## ***Environmental Planning Commission***

***Agenda Number:04  
Project #: PR-2018-001734  
VA-2020-00375  
Hearing Date: January 21, 2020***

### ***Staff Report***

The request for a Variance – EPC for a future dwelling located at 7828 Aguila St. NW (the subject site). The Variance – EPC request is for a proposed structure (single family dwelling) to be built in the Northwest Mesa Escarpment VPO (VPO-2). Pursuant to IDO subsection 14-16-3-6(E)(2). The purpose of this VPO is to protect views looking to and from the Petroglyph National Monument, Volcanic Escarpment, and Volcano Mesa.

*East Elevation*

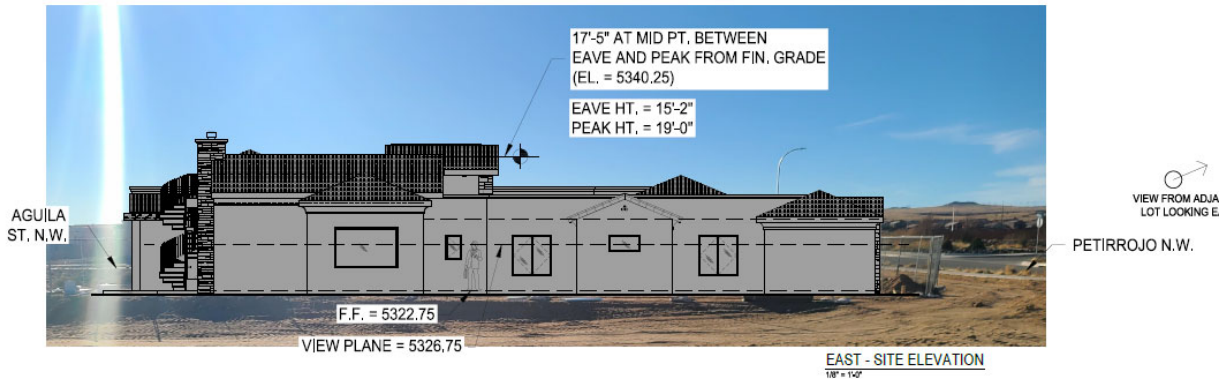
The North Elevation drawing of the subject site demonstrates the visual impact of the views looking south towards the proposed home. One can see that the southern portion of the Sandia Mountains are still visible to the east, though this portion of the Sandia Mountains is significantly lower than the peak. This drawing shows that the visual impact is not greater were the building be at or under the 15-foot height limit. The Boca Negra Canyon is south of the subject site. The distance to the escarpment from the subject site is such that the view of the Boca Negra Canyon is already blocked by the escarpment edge. The structure does not add additional impediment to the view, nor does the additional structure height.

The East Elevation drawing of the proposed structure demonstrates the views looking westward to the eastern face. In this direction, one is looking westward towards the Volcanoes. From this view, the height difference does not create more of an impact to the view to the Volcano. Some Volcanoes are still visible north of the structure. The lower portion of the house is still higher than the volcano that is still visible, thus demonstrating that the additional height does not create additional impact.

*West Elevation*

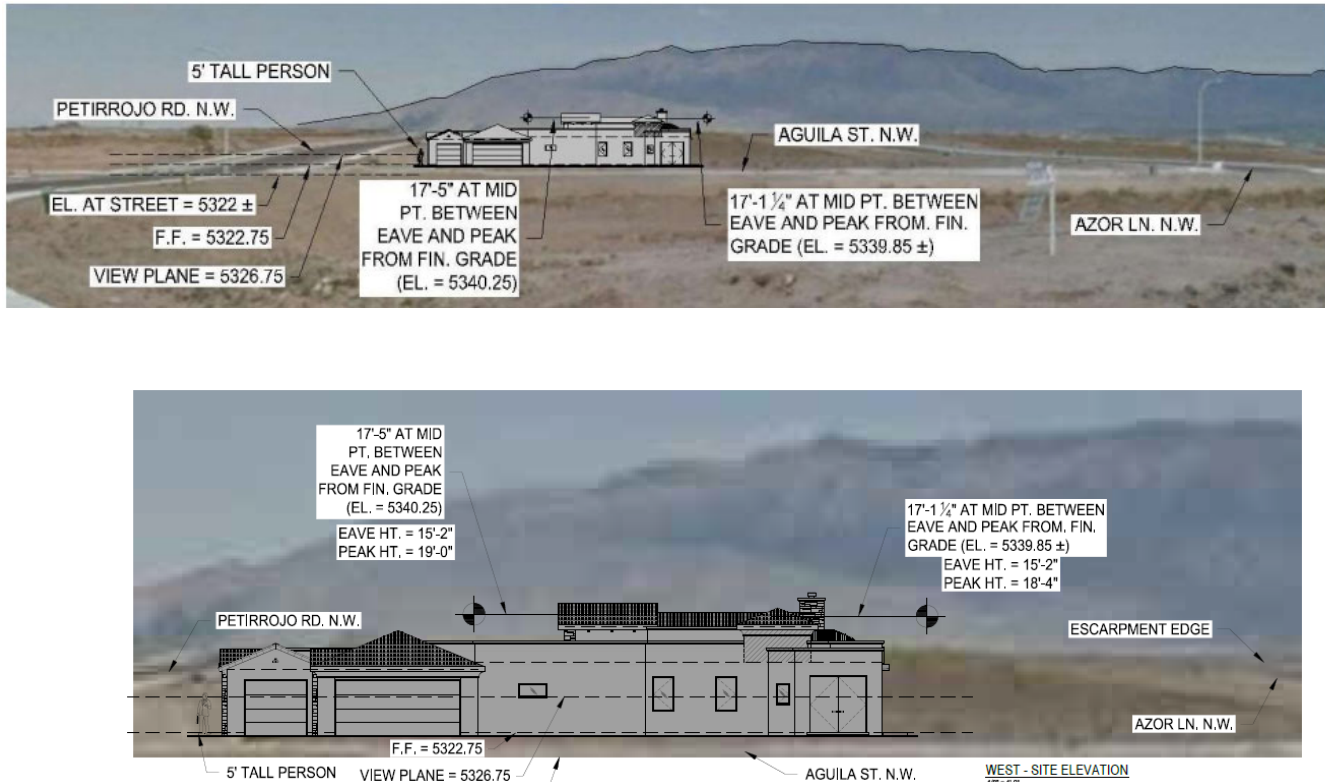
The West Elevation drawing of the proposed structure demonstrates the views looking eastward to the western face of the building. It was recommended that the applicant take the western elevation from a viewpoint that is further away from the building as to accurately represent someone looking towards the mountains in this direction. The Northwestern Mesa VPO-2 view plane analysis standards are less developed than the Coors Blvd VPO-1 standards. The applicant and city staff worked together to come to an agreement as to what should be shown in the drawings. The structure does not pierce the ridge line of the Sandia's from this viewpoint and leaves the view largely unobstructed.

Figure 1: Replace elevation of Coors Blvd. with elevation of nearest public right of way, include all requirements called out in 6-6(M)(2)(e)2

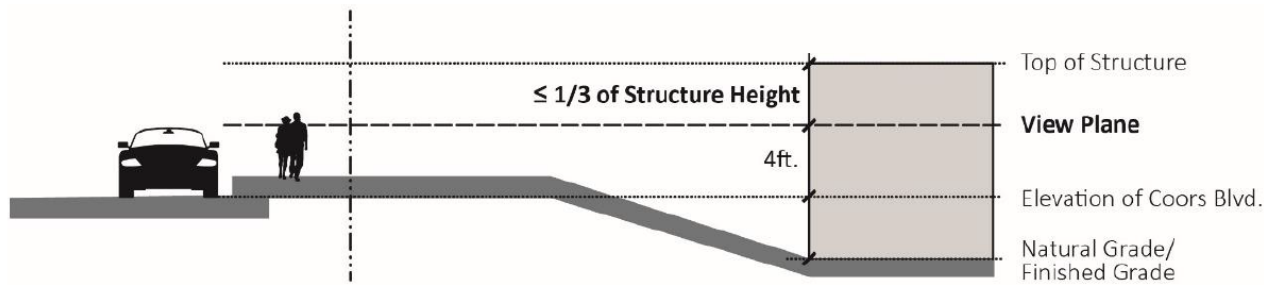
2. View plane exhibits that illustrate the expected impact of structure height on major public views given the relationship of slopes, building heights, setbacks, escarpment height, and view corridors. (See figure 1)

SITE SECTIONS  
WEST AND NORTH  
GONZALES RESIDENCE

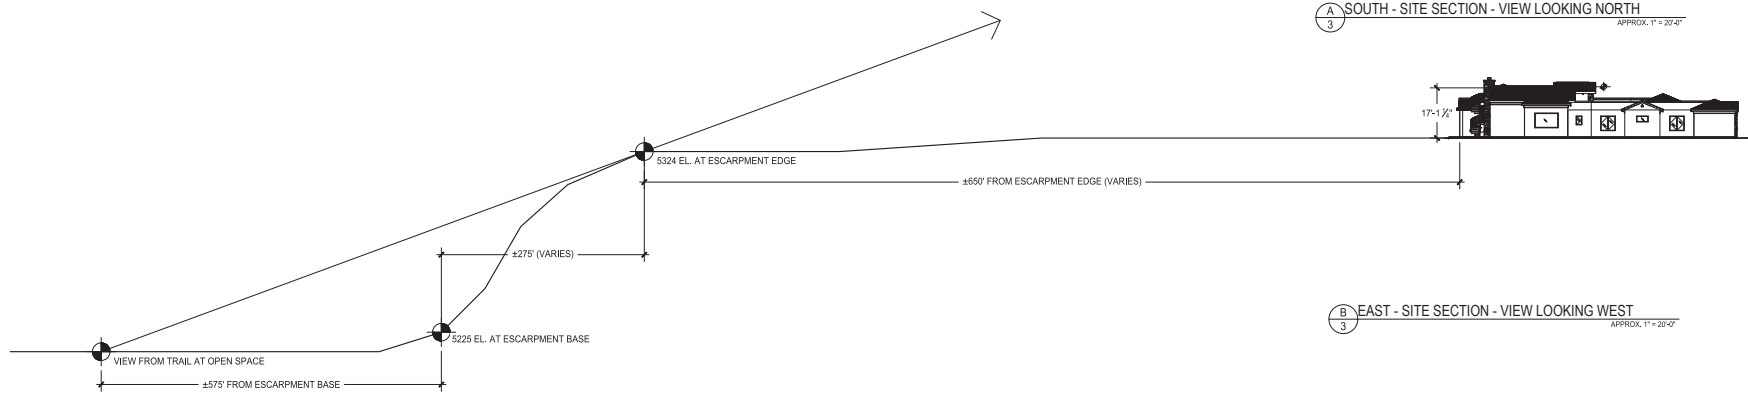
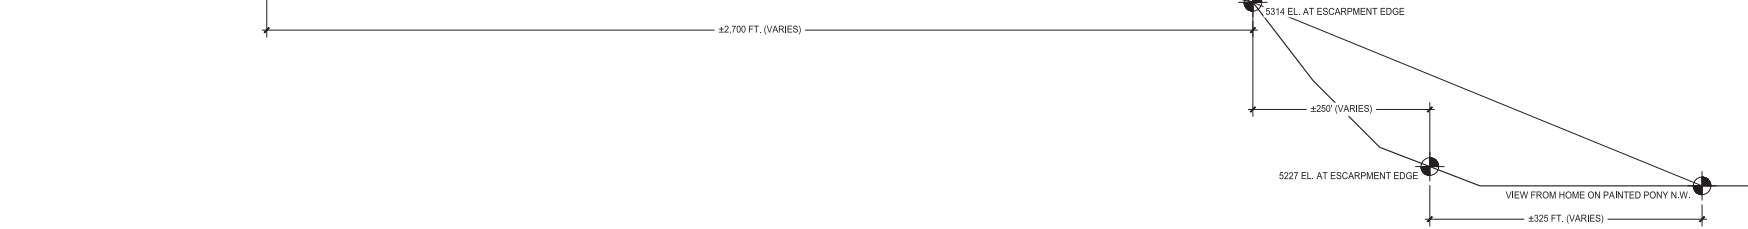
The North Site Section drawing is looking southward to the northern face of the proposed structure. The section displays the elevations of various points of the site, escarpment, and nearby viewpoints. The finished floor is at roughly 5322.25' in elevation, the distance from the site to the escarpment edge varies but the drawing is shown at roughly 2,700' from the escarpment edge. The midpoint from the subject site to the escarpment edge has an elevation of 5342' (taken at the right of way, Urraca NW), the escarpment edge has an elevation of 5314'. The escarpment base has an elevation of 5220' and the viewpoint is taken from homes at Painted Pony NW, looking up towards the escarpment edge. The site section clearly demonstrates that the proposed site does not obstruct the view looking up toward the escarpment as it is at such a great distance from the escarpment edge. The subject site dips lower than the average height of the top of the escarpment edge, further lending itself to unobstructed views. The Subject site is roughly 100' higher than the escarpment base, and at this point is roughly 2,700' from the escarpment edge, these two elements combined ensure unobstructed views to and from the escarpment. This also clearly demonstrates that the requested additional 2'-5" in height does not increase the impact on the views.

The West Site Section drawing is looking eastward to the western face of the proposed structure. The section displays the elevations of various points of the site, escarpment, and nearby viewpoints. The finished floor is at roughly 5322.25' in elevation, the distance from the site to the escarpment edge varies but the drawing is shown at roughly 900' from the escarpment edge.

SITE SECTION  
SOUTH AND EAST

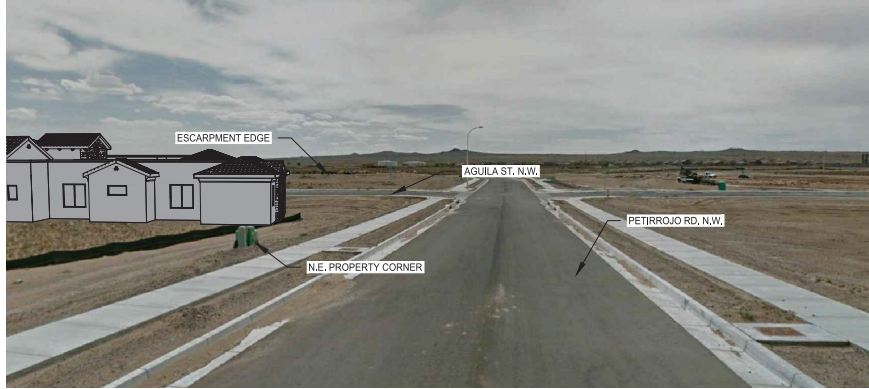
The East Site Section drawing is looking westward to the eastern face of the proposed structure. The section displays the elevations of various points of the site, escarpment, and nearby viewpoints. The finished floor is at roughly 5322.25' in elevation, the distance from the site to the escarpment edge varies but the drawing is shown at roughly 650' from the escarpment edge. The escarpment edge has an elevation of 5324'. The escarpment base has an elevation of 5225' and the viewpoint is taken from walking paths at Open Space, looking up towards the escarpment edge. The site section clearly demonstrates that the proposed site does not obstruct the view looking up toward the escarpment as it is at such a great distance from the escarpment edge. The Subject site is roughly 100' higher than the escarpment base, and at this point is over 1,225' from the escarpment edge, the difference in height and distances to and from the escarpment ensure unobstructed views from below.

The South Site Section drawing is looking northward to the southern face of the proposed structure. The section displays the elevations of various points of the site, escarpment, and nearby viewpoints. The finished floor is at roughly 5322.25' in elevation, the distance from the site to the escarpment edge varies but the drawing is shown at roughly 2,700' from the escarpment edge. The midpoint from the subject site to the escarpment edge has an elevation of 5342' (taken at the right of way, Urraca NW), the escarpment edge has an elevation of 5314'. The escarpment base has an elevation of 5220' and the viewpoint is taken from Painted Pony NW, looking up towards the escarpment edge. The site section clearly demonstrates that the proposed site does not obstruct the view looking up toward the escarpment as it is at such a great distance from the escarpment edge. The subject site dips lower than the average height of the top of the escarpment edge, further lending itself to unobstructed views. The Subject site is roughly 100' higher than
